# Taylor Wimpey and Homes England

Pickering's Farm Planning Appeal

VN211918 Transport and Mobility Rebuttal of Mr N. Stevens and Dr. D Price Evidence

Technical Note 14: Response to LCC Modelling Proof of Evidence

**Figure 1 Link Flow Analysis Locations**

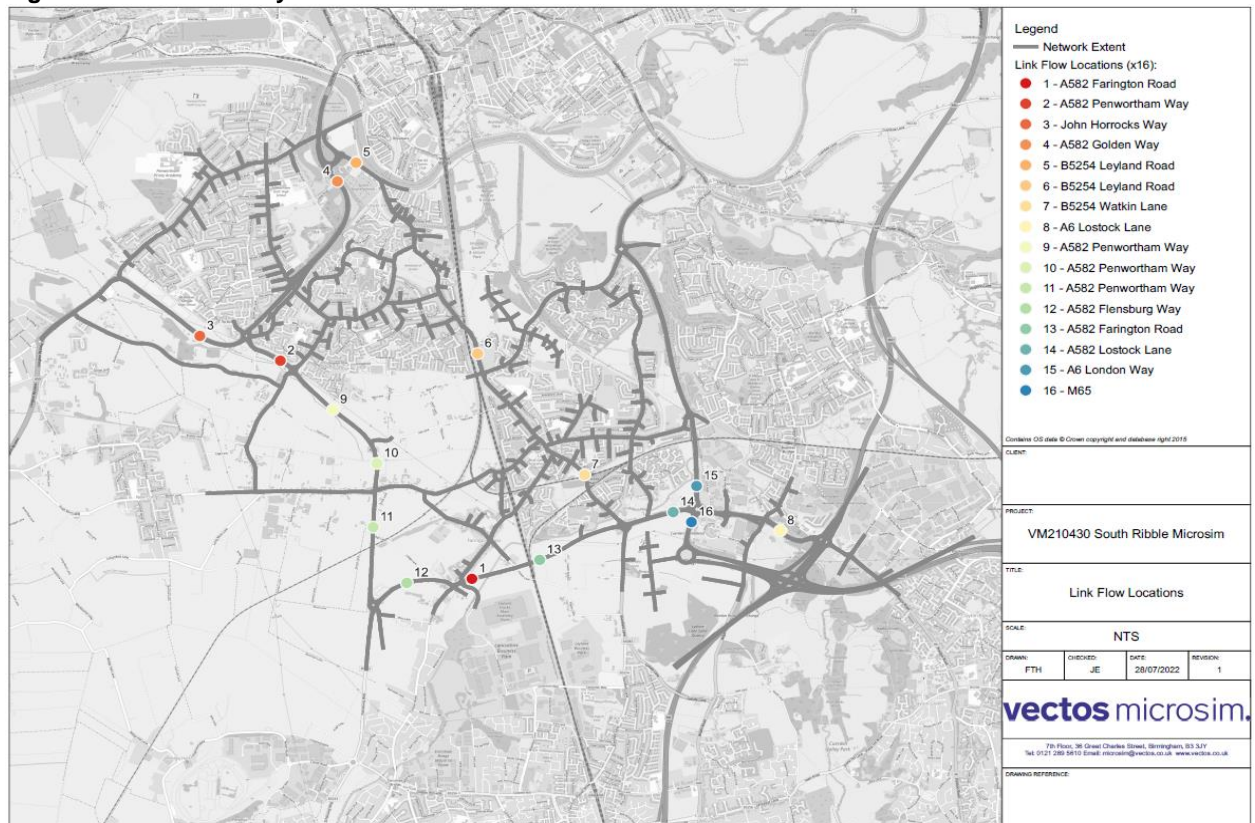
- 77. In order to document the differences between the background traffic data underpinning each assessment, the LCC and Vectos traffic flows have been reported for key links across the network, as presented within **Figure 1**, and reported within the following table.

- 78. This presents the LCC traffic flows, the Vectos 2021 traffic flow data. The intention here is to highlight any key differences in data sets by location. Within the flow analysis we have also presented a 10% uplift scenario whereby traffic volumes have been arbitrarily uplifted by 10% to assess the implications of such a change on network operation. Caution should be exercised when viewing these results as it is representing a significant over simplification of network operational effects. This point is discussed further towards the end of this note.

Figure 4 Journey Time Impacts – A582 Corridor - Northbound

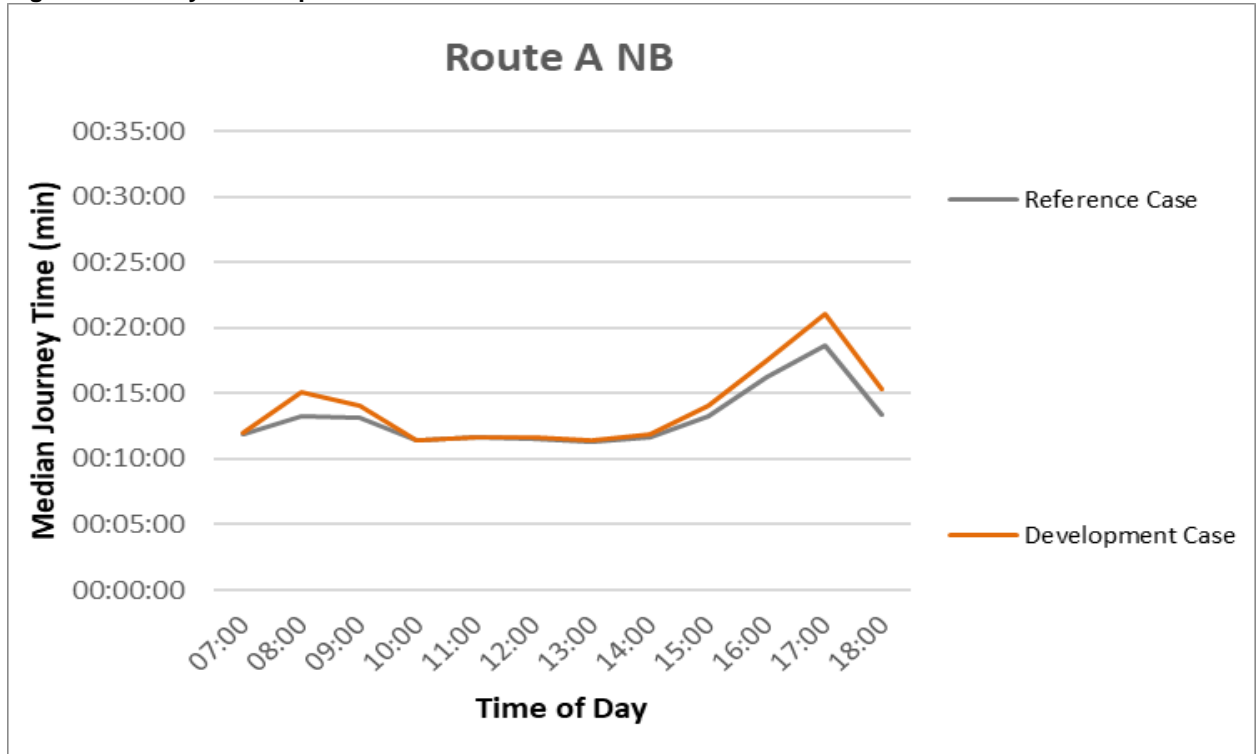
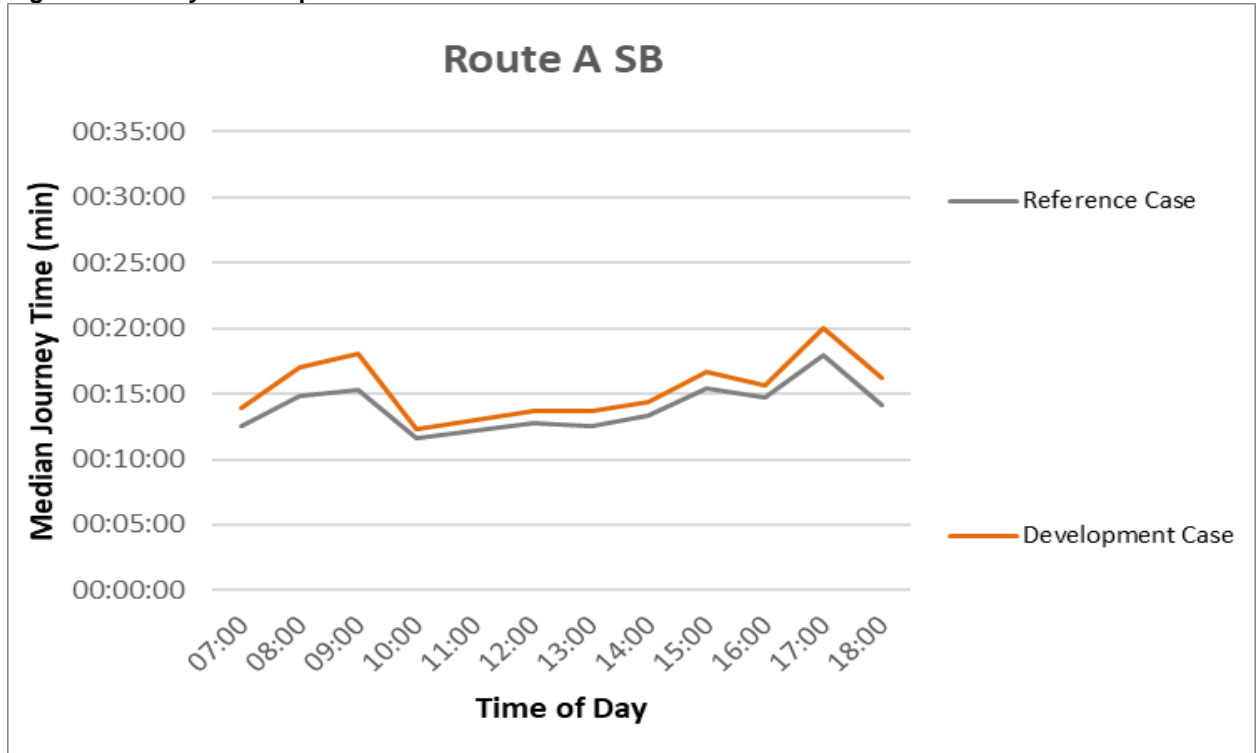
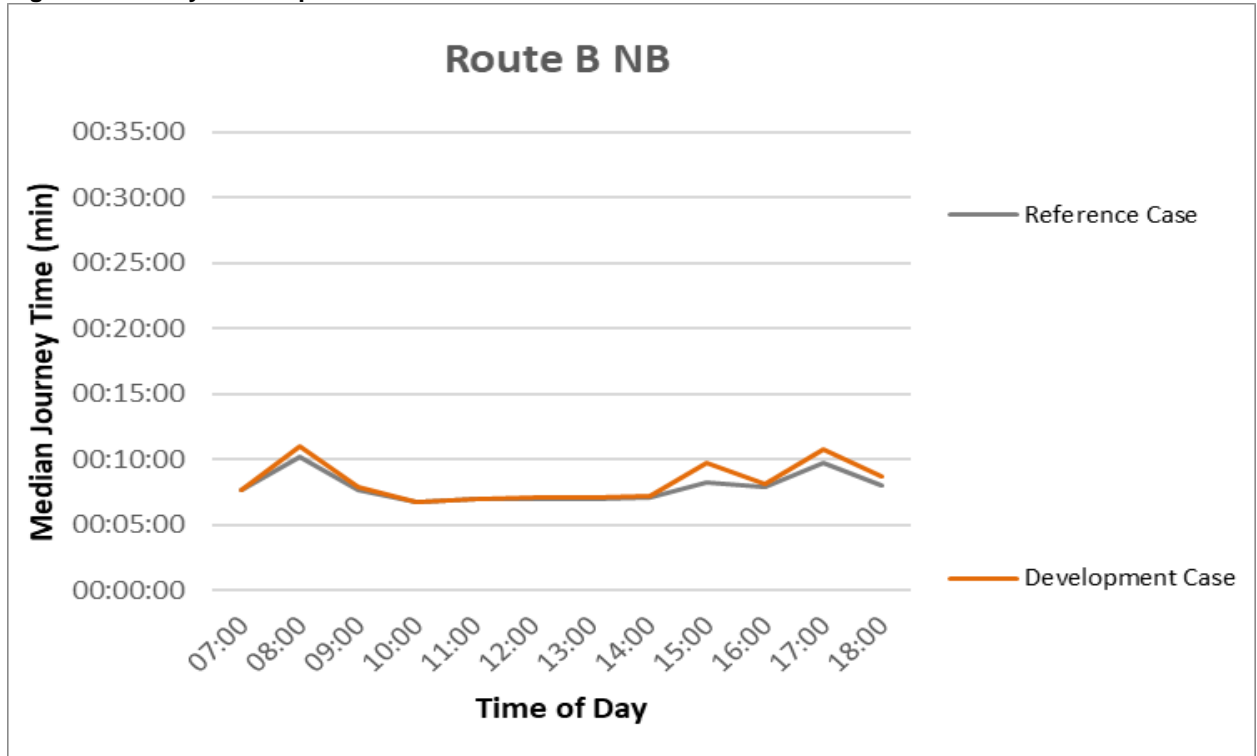
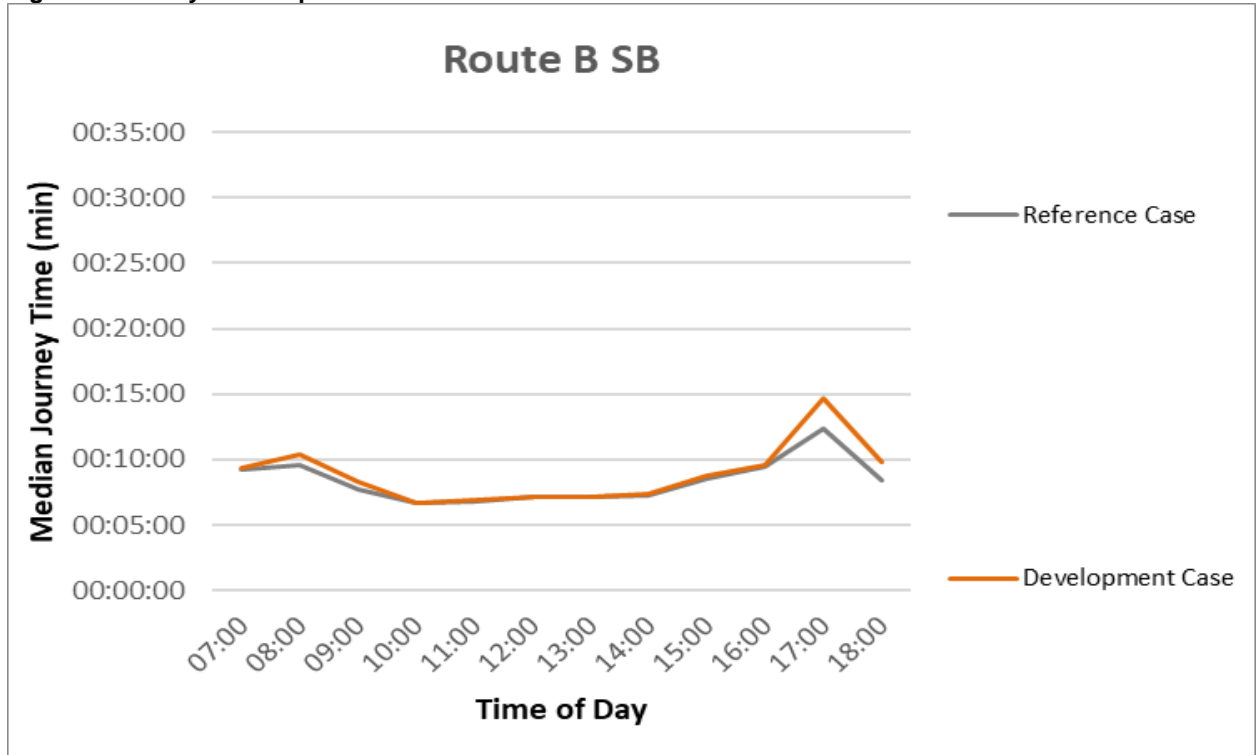
- 131. Analysis of the journey time results presented within **Figure 4 to Figure 7** indicates that the development impacts across the 12 hour period considered are minimal, with the journey times on both the A582 and B5254 corridor on the most part being within 60 seconds of those reported in the Reference Case across the day.
- 132. Within the PM peak hour (1700-1800) the difference between the Reference Case and Development Case journey times does increase to a maximum of 2 minutes 20 seconds, (Route A NB), however, this reflects the maximum difference in journey times along the corridor, and in the context of the Reference Case journey times on this route being almost 19 minutes in the peak hour, a 2 minute increase in the busiest hour is not considered significant.

Figure 8 Journey Time Impacts (Development Trip Gen Sensitivity Test) – A582 Corridor – Northbound

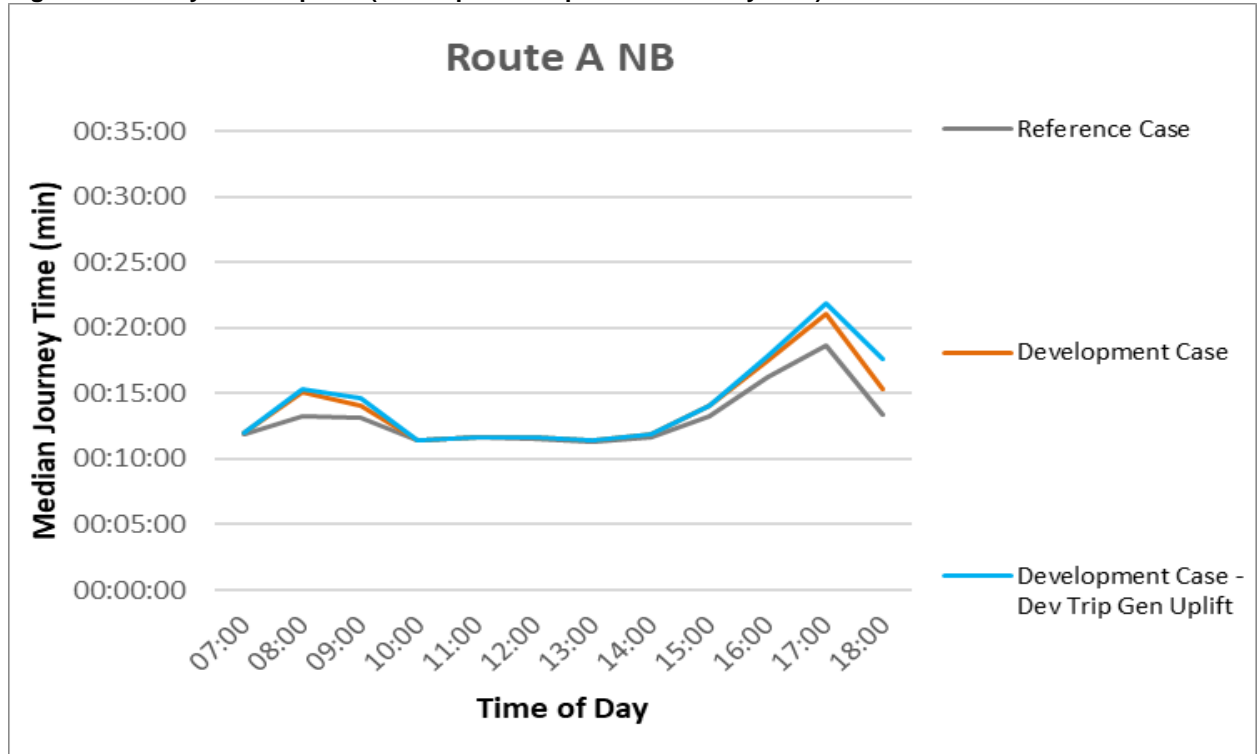
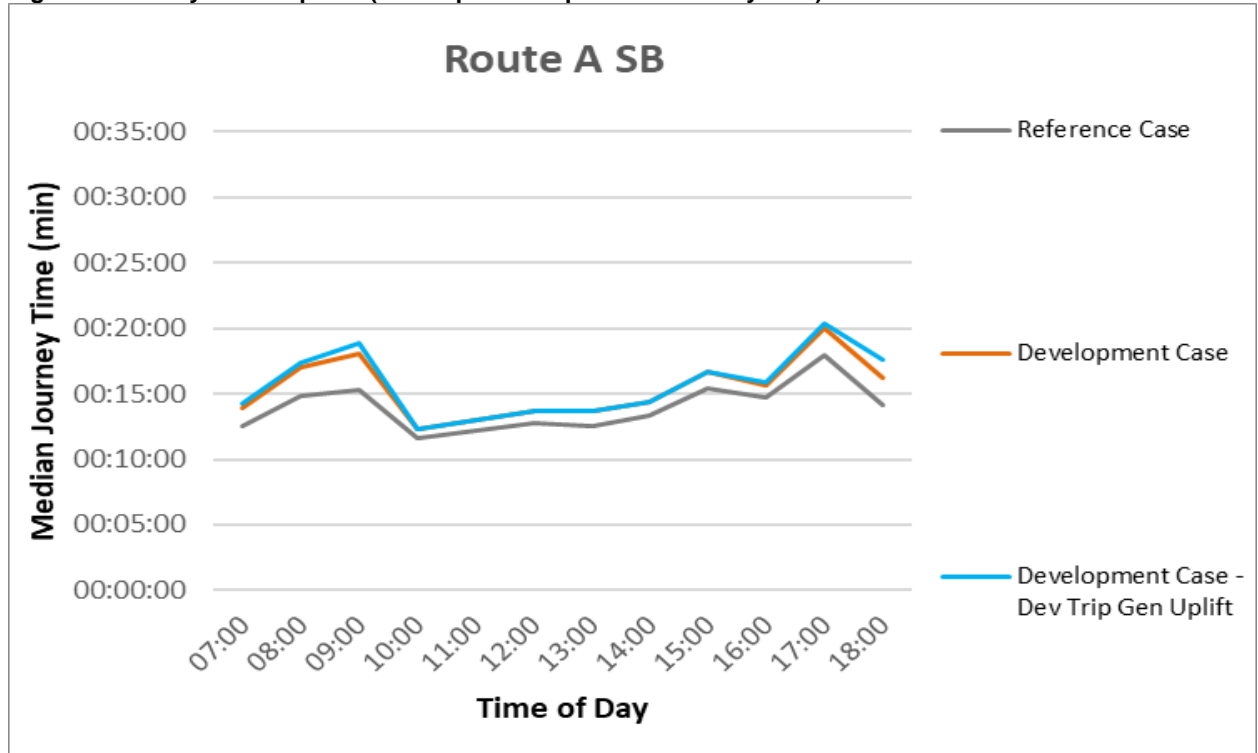
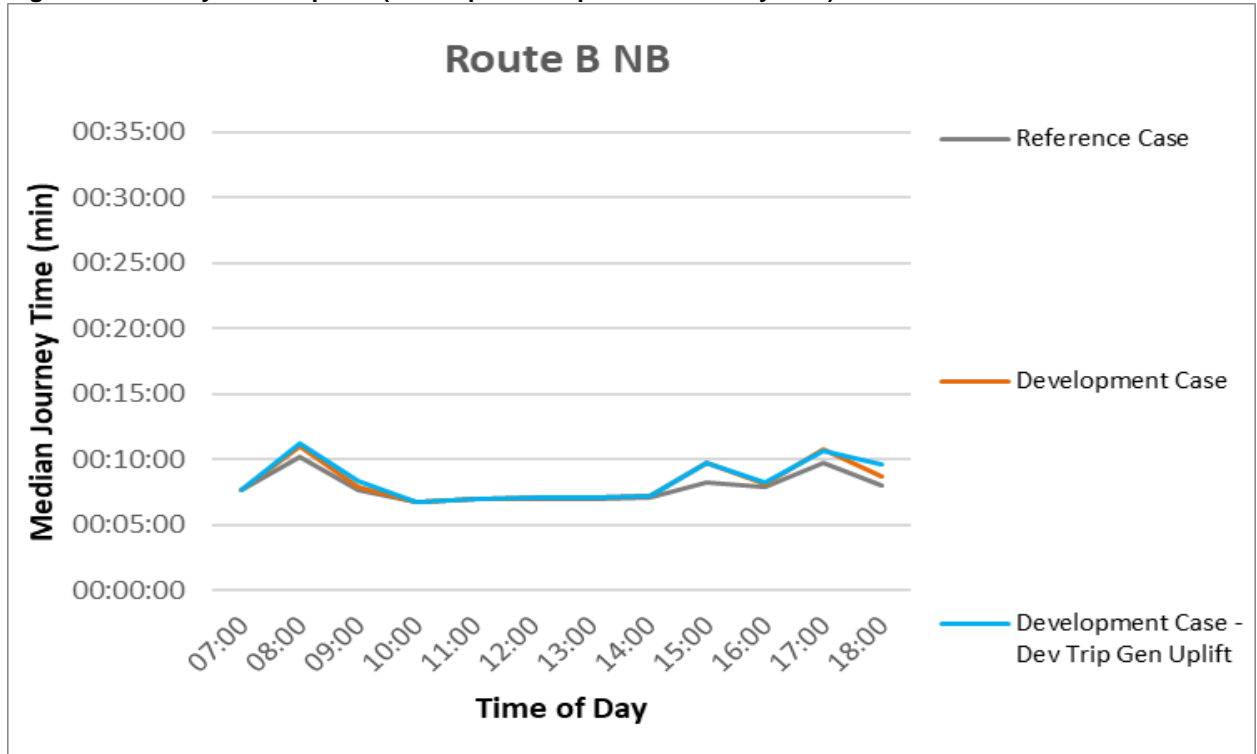
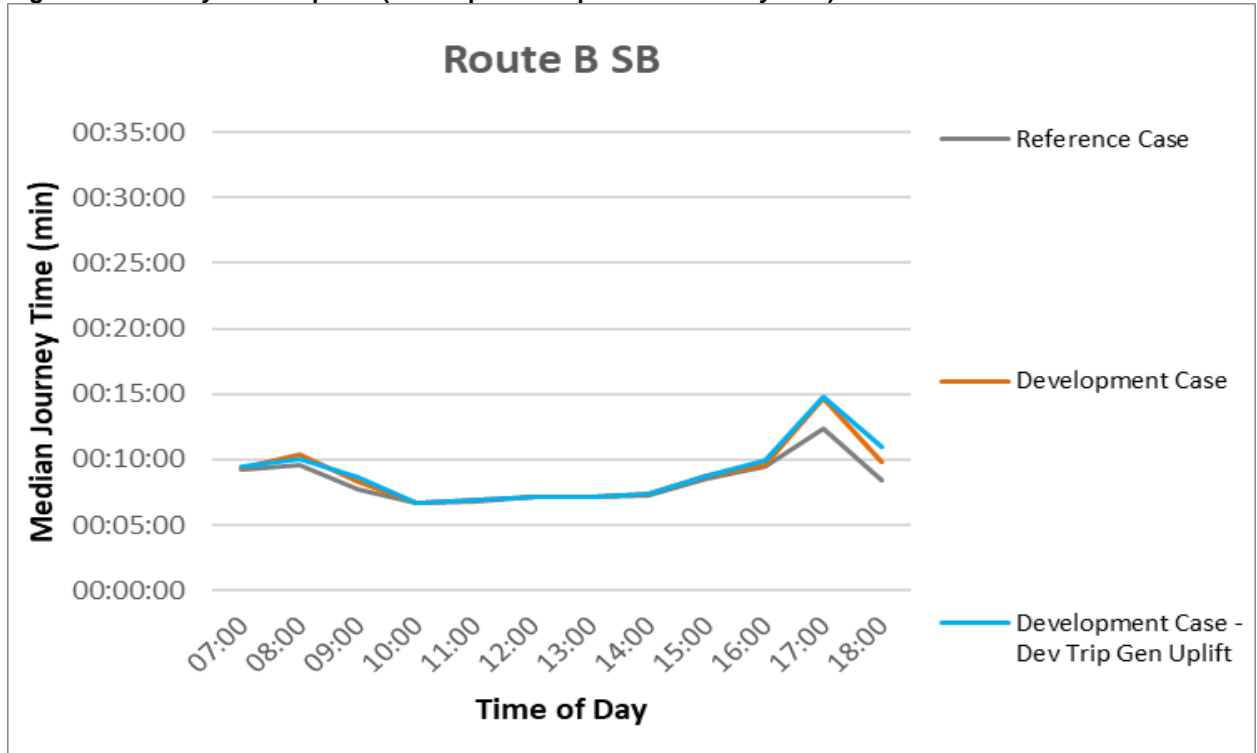
136. The results presented in **Figure 8** to **Figure 11** indicate the modelled impact on journey times across the key corridors, once an uplifted trip generation has been assigned to the Pickerings Farm development traffic. As set out within **Table 15**, the uplifted trip generation tested is higher than that assumed by LCC for the AM peak hour, and marginally lower for the PM peak hour.

137. It is clear from the journey time results presented within these graphs, that the uplifted trip generation has no significant impact on the originally reported Development Case journey times, with the most notable difference reported being around a 60 second increases on Route A NB in the PM peak hour.

138. On the basis of the results reported within these figures, and considering that the sensitivity test trip generation are broadly in line with those derived by LCC, it is clear that there will be no notable change to the originally reported model results if the development trip generation was to be increased in response to the LCC comments on the trip rates.
